JANUARY 19, 2021 MEETING

AGENDA

TO: The Town of Lewisboro Planning Boar
FROM: Lewisboro Conservation Advisory Council
SUBJECT: **McGuiness Residence, 17 Schoolhouse Road**
South Salem, NY 10590
DATE: January 13, 2021

**Re: 17 School House Road
Sheet 22, Block 10802, Lot 35
Application for Wetland Permit and Stormwater Permit**

SITE PLAN - SUBJECT AREA 1

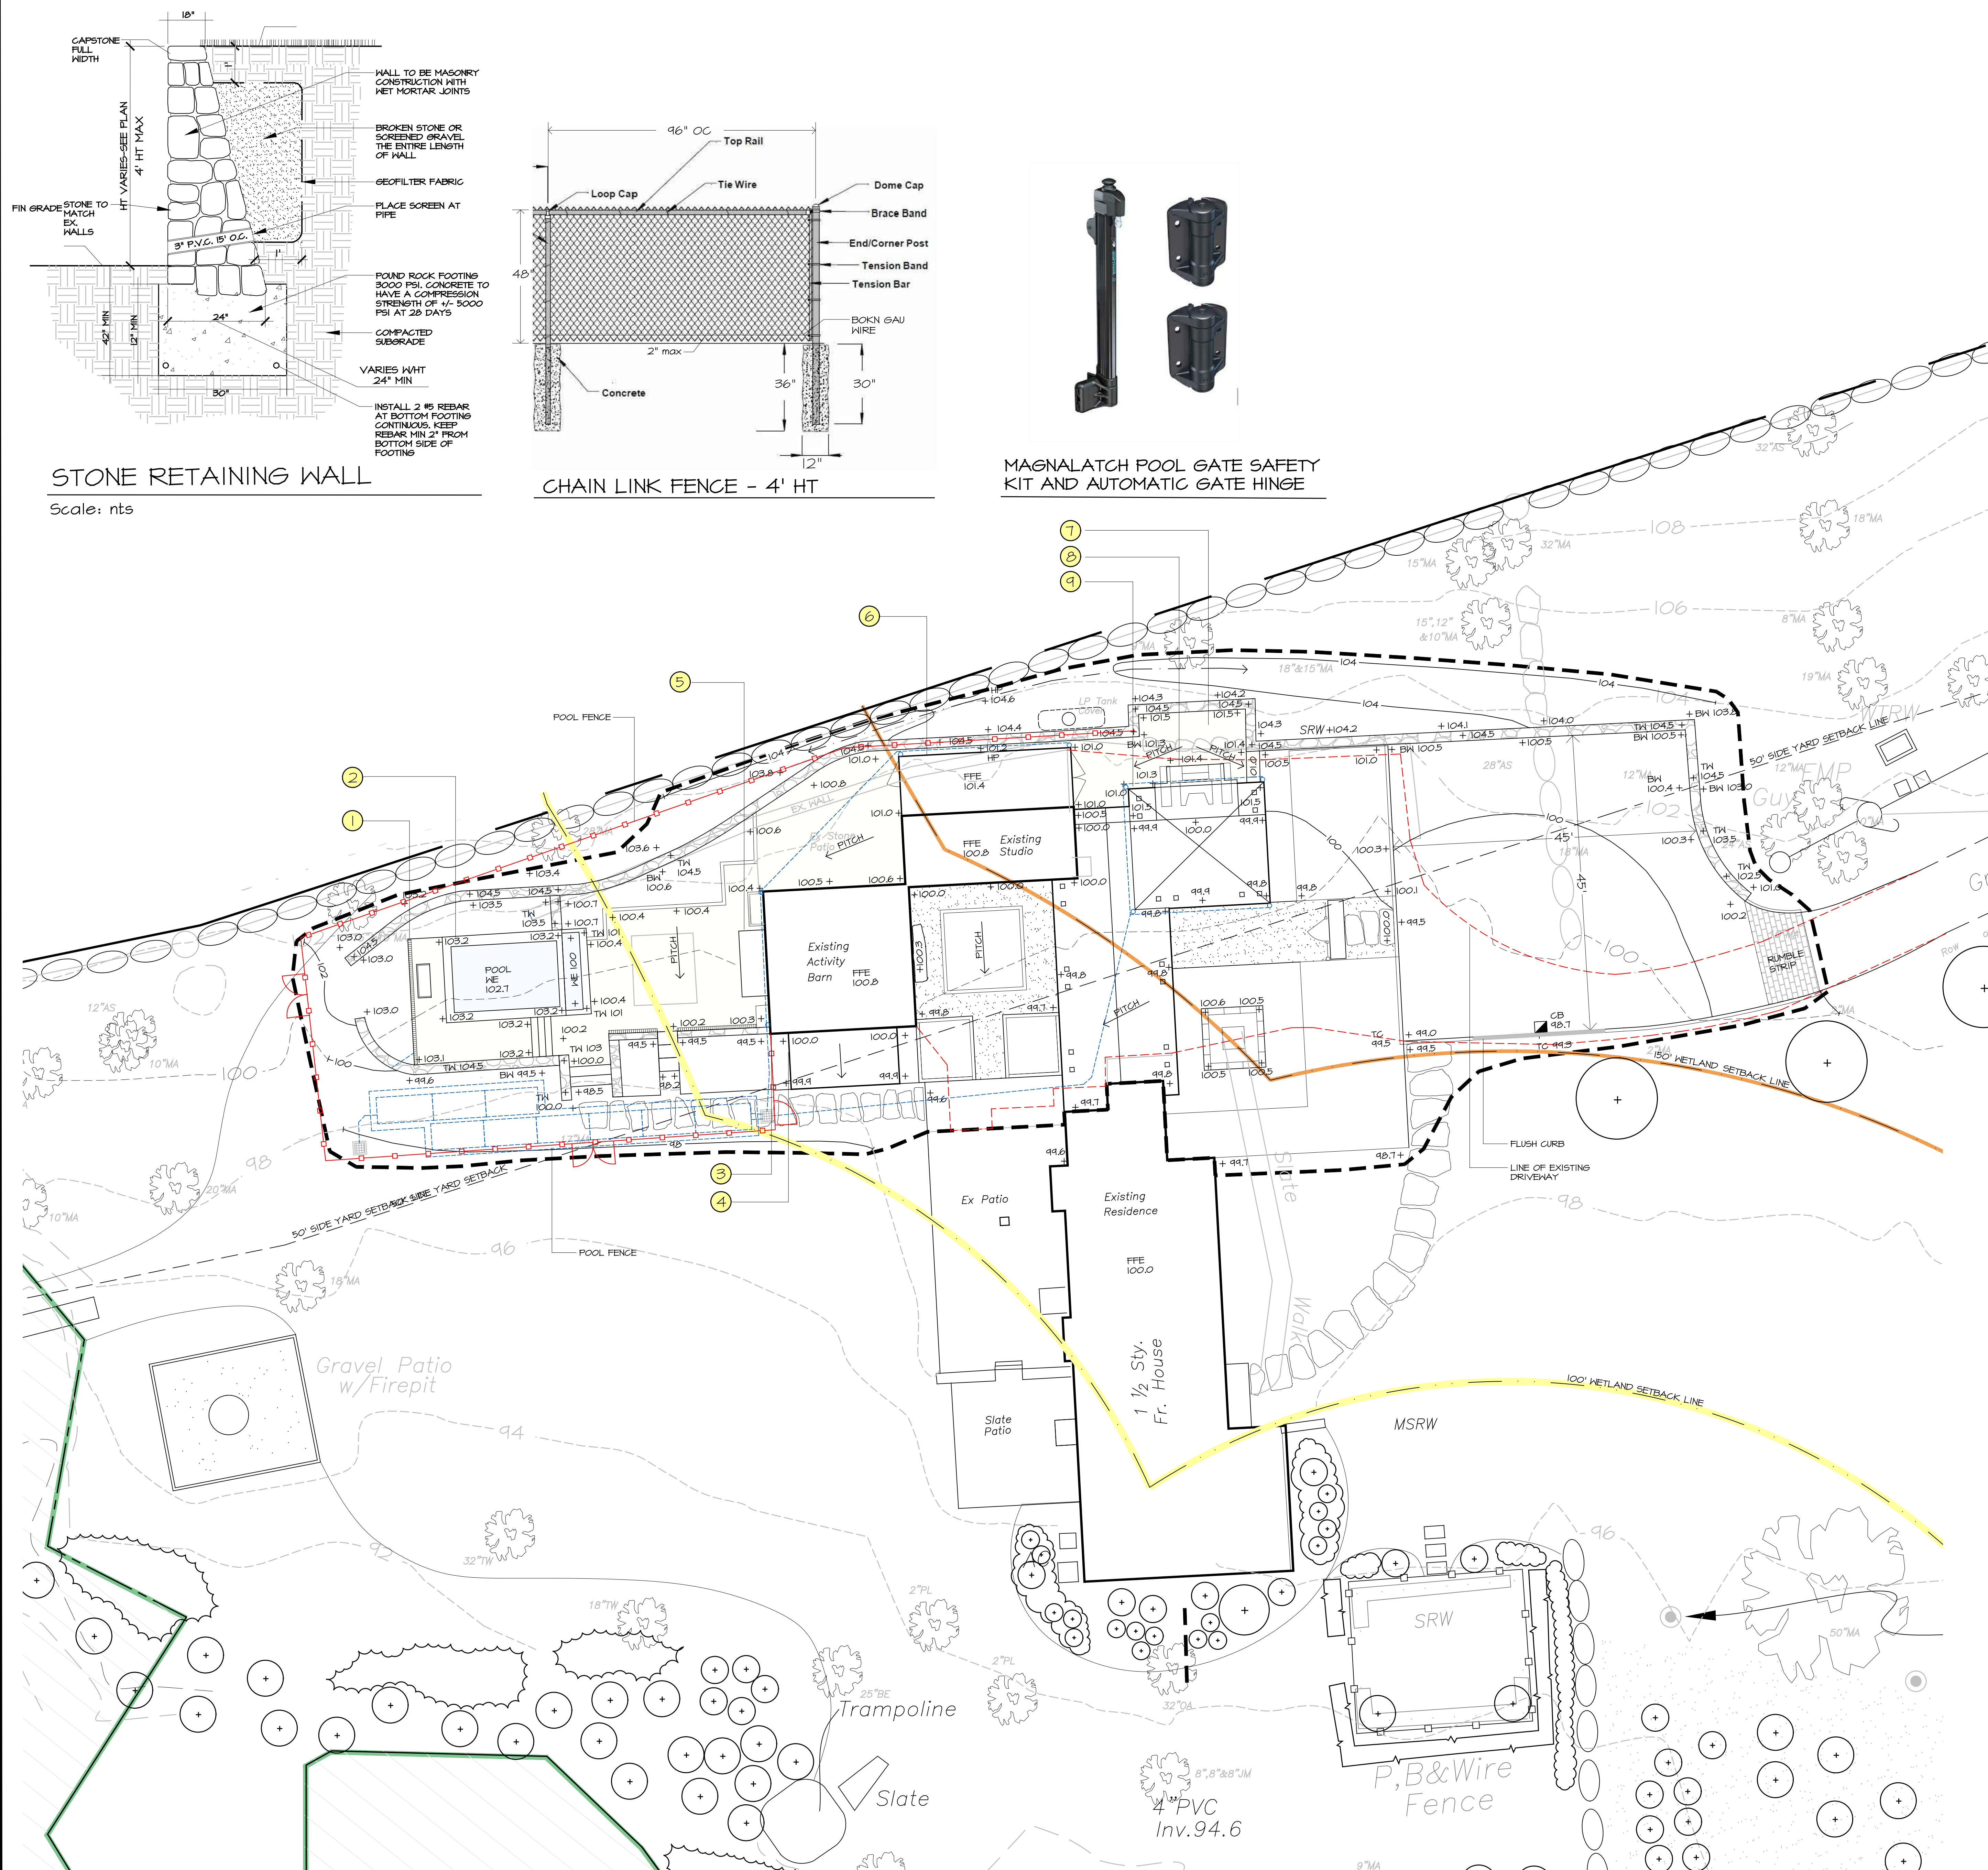
11. Comment #11 regarding Professional Seals of Plans. All final plans shall bear the professional seal of the professional who prepared them.
12. Comment #12 regarding Parking Court Size. The proposed gravel parking court area dimensions are now shown on the Grading Plan, Sheet 3 of 4. The gravel parking court area measures approximately 45' x 45'.

13. Comment #13 regarding Wall Elevations. Retaining wall elevations are shown on the Grading Plan, Sheet 3 of 4. All proposed retaining walls shown on the plan are a maximum of 4' height or less. A typical retaining wall detail has been added to the plan.
14. Comment #14 regarding Pool/Spa Fence. The proposed pool/spa shall be equipped with a safety cover that will be kept closed when the pool is not in use. Keeping the cover closed helps maintain pool water temperature and decreases pool water and pool chemical evaporation. It also helps keep yard debris (sticks, leaves) out of the pool. The safety cover will also support the weight of a person who may accidentally fall onto the cover. The safety auto-cover will be installed in addition to a pool fence to meet minimum NYS Building Code.

The Grading Plan, Sheet 3 of 4, shows the location of the proposed pool fence. The pool fence shall enclose the pool and patio area behind the activity barn. The fence will be tied off on the east and west side of the activity barn. Access gates and maintenance gates are also shown on the plan. A typical chain-link pool fence is shown on the plan as a "place holder", until the owner makes a final fence style selection.
15. Comment #15 regarding Utilities. The location of the septic system, potable well, propane tank and electrical service lines are shown on Sheet 1 of 4, Overall Property & Existing Conditions Plan.
16. Comment #16 regarding Construction Details. The final project plans shall show all relevant construction details on the Architectural, Civil Engineering and Landscape Architecture Plans.

EROSION CONTROL & SITE
MITIGATION PLAN

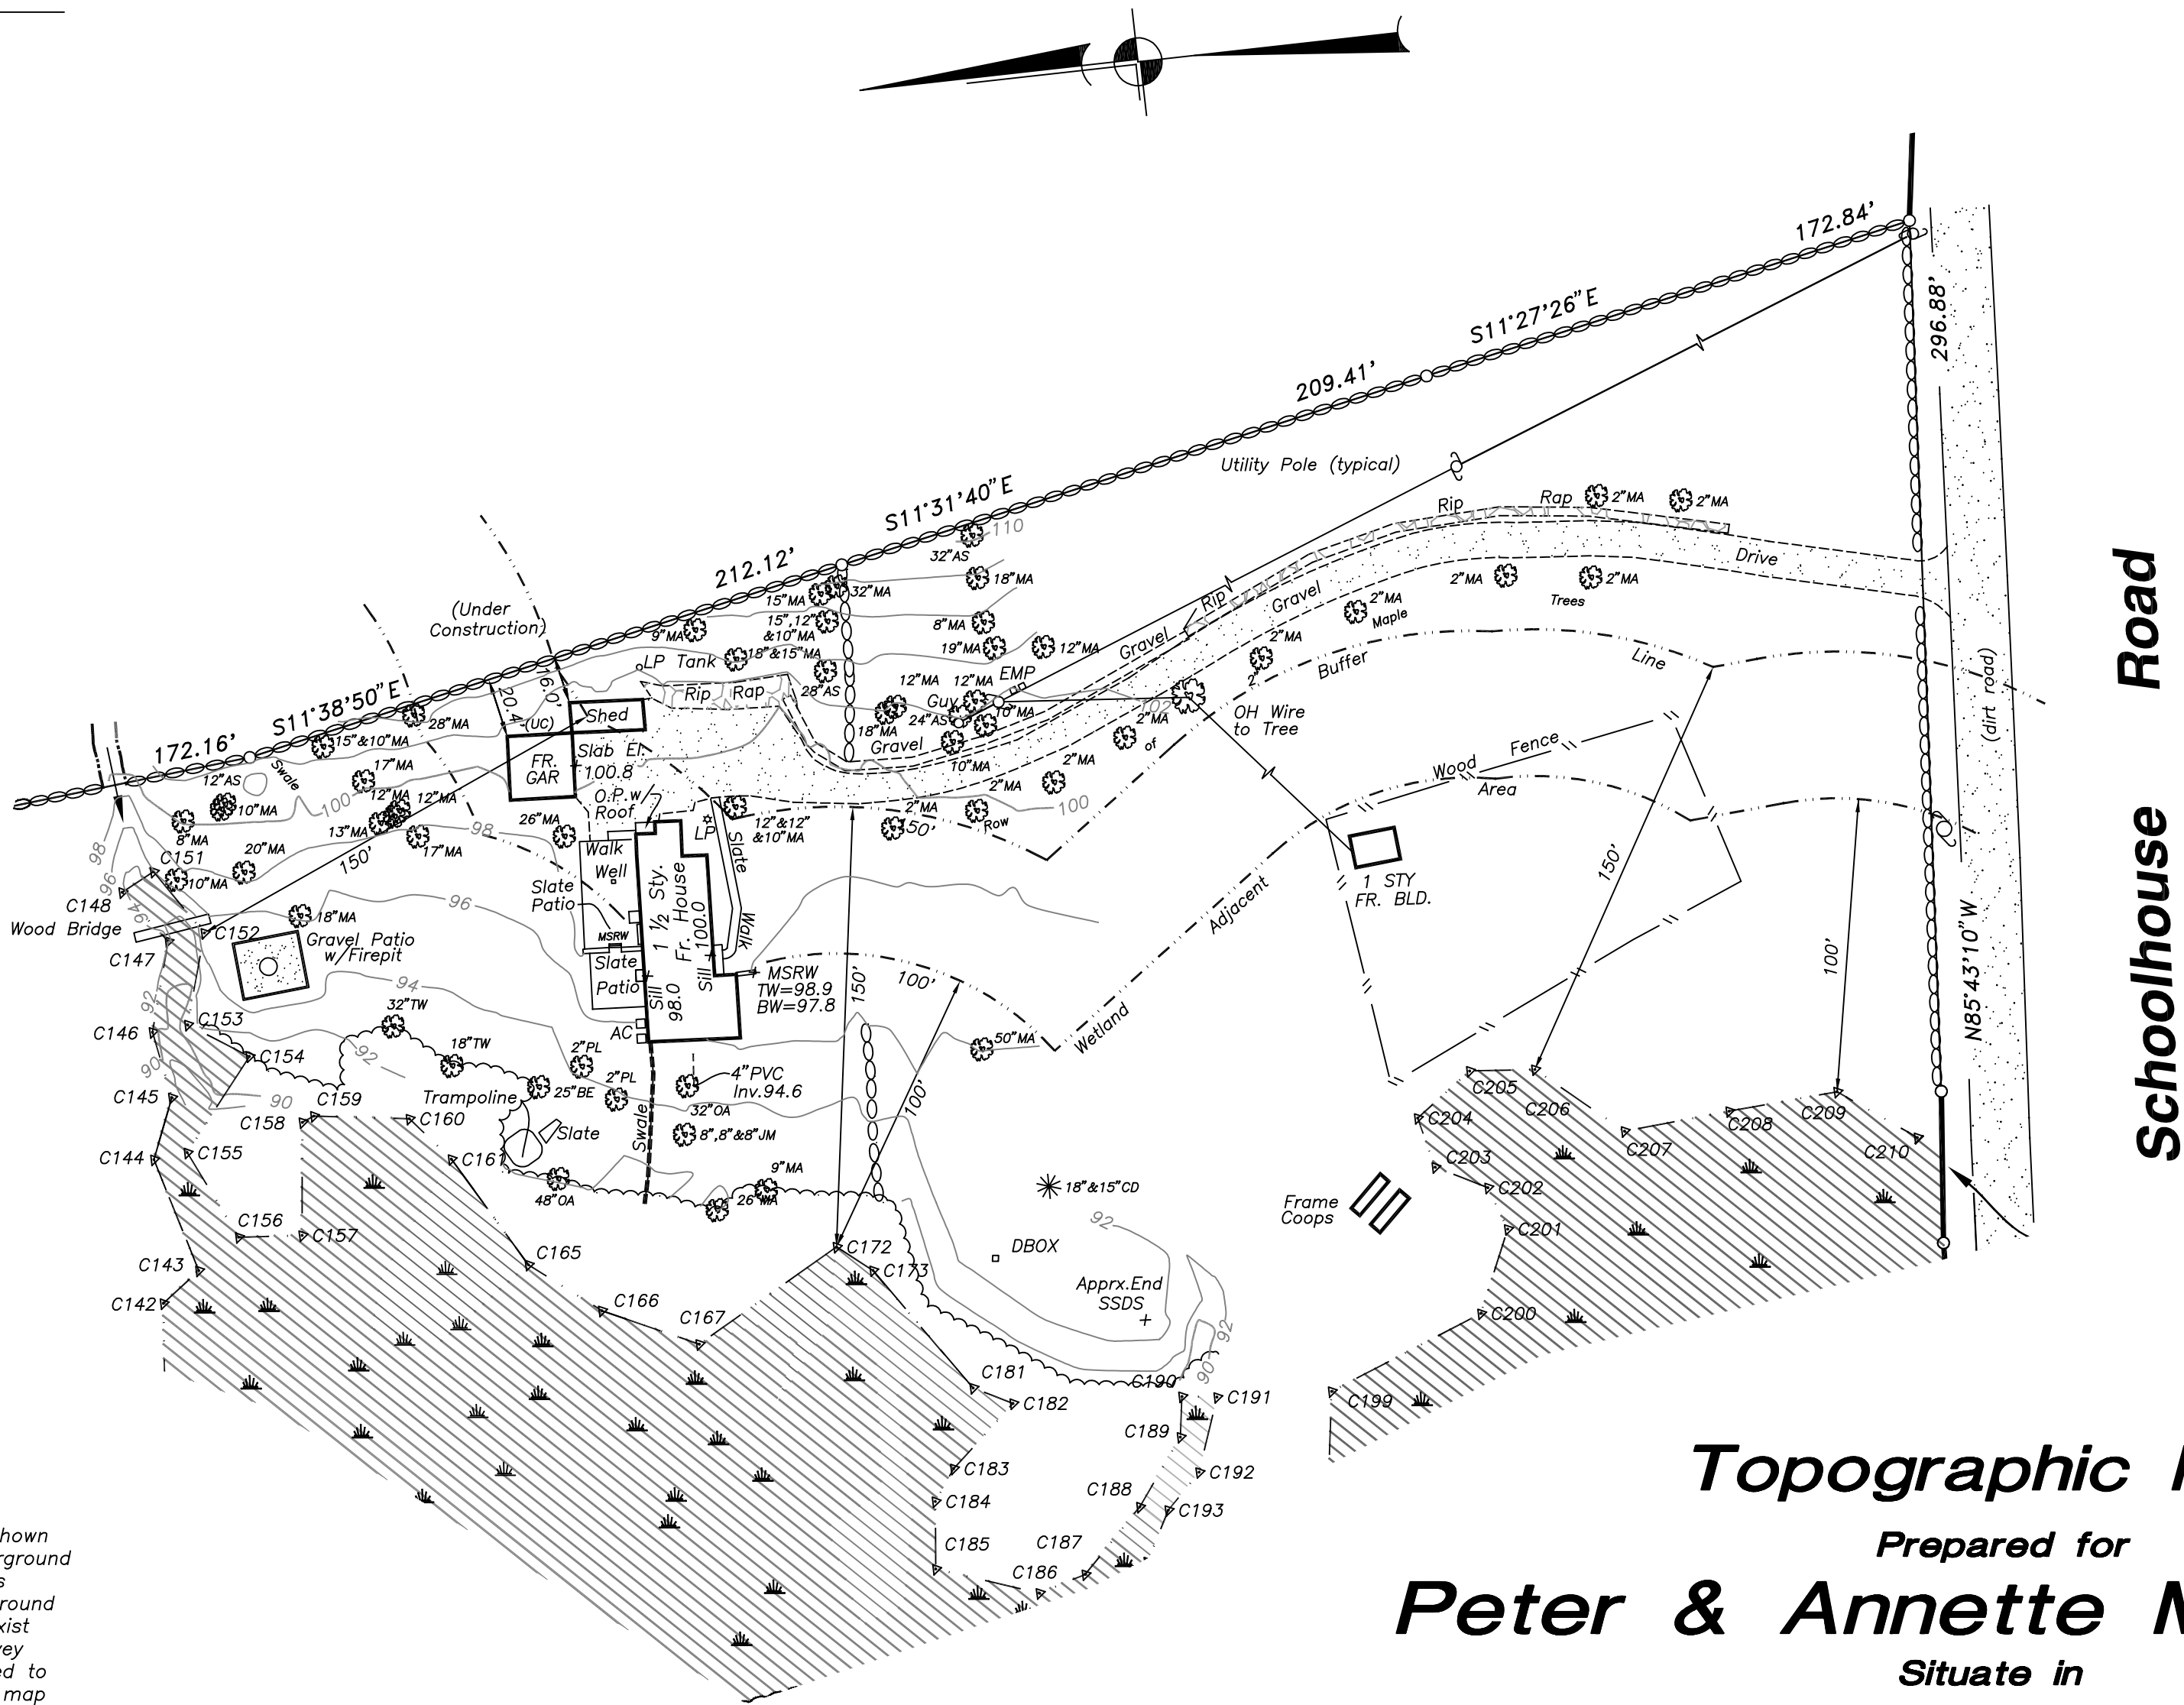
Comment C regarding 1:1 Wetland Mitigation Plantings. See response #4 above regarding wetland mitigation

Comment D regarding Legend for Proposed Plantings. Once the wetland planting mitigation concept is reviewed with the PB and the areas are agreed upon, we will then detail the planting plan with specific plantings of trees, shrubs, groundcovers, ferns, forbs and perennials to create a dense and enhanced wetland mitigation planting area. Botanical and common names, plant sizes and quantities, with representative plant photographs will be shown on the final wetland buffer planting plan.

Comment E regarding Effective Mitigation. We believe that creating denser plantings in wetland buffer filter strips, like those shown on the western side of the property, to be a viable practice to creating a more effective wetland buffer/filter strip. Filter strips function when installed plantings send out their roots to anchor the plants and absorb moisture and nutrients to sustain the plants. Adding additional plantings to the existing plantings will increase the root mass in the soil horizon throughout the filter strip. This not only helps stabilize the soils in the buffer, but it is the root mass that will absorb the stormwater runoff and associated pollutant loads in the stormwater, i.e., nitrogen, phosphorus and potassium. The filter strip plantings function where the suspended pollutants in the stormwater runoff are bound to the soil particles as the water passes through the soils. Eventually the pollutants are absorbed into the plants as nutrients to maintain plant growth. When the plant dies, it decomposes and the nutrients are returned to the soil. Hence, adding more plants and their associated root systems to the wetland buffer enhancement plantings/filter strips will serve to increase the absorption of stormwater borne pollutants into the plantings before the pollutants can enter the wetland. In our opinion, the additional mitigation plantings added to the existing mitigation plantings/filter strips, will have a beneficial effect by improving the efficiency of the filter strips and, thereby, protecting the wetland from excessive pollutant loading resulting from stormwater runoff.

Comment F regarding Wildflower Garden as Mitigation. We believe that the proposed wildflower garden down slope of the proposed new greenhouse will provide effective mitigation as the wildflower garden shall serve as a filter strip for stormwater runoff traveling toward the wetlands. As previously noted to the PB during earlier project discussions, wildflowers and prairie type grasses are known to have extensive fibrous root systems that can travel through the soil for depths of 1'-10'. This allows them to penetrate the soil to various depths to absorb moisture and nutrients. Inasmuch, wildflowers and prairie type grasses make for excellent filter strip plantings. Once the mitigation concept is agreed to, we will fully detail the wildflower meadow planting down slope of the proposed greenhouse. We attach to this document, for the PB's and CAC's information, a cut sheet showing the relative depths that some typical wildflowers and prairie grasses extend their root systems into the soil.
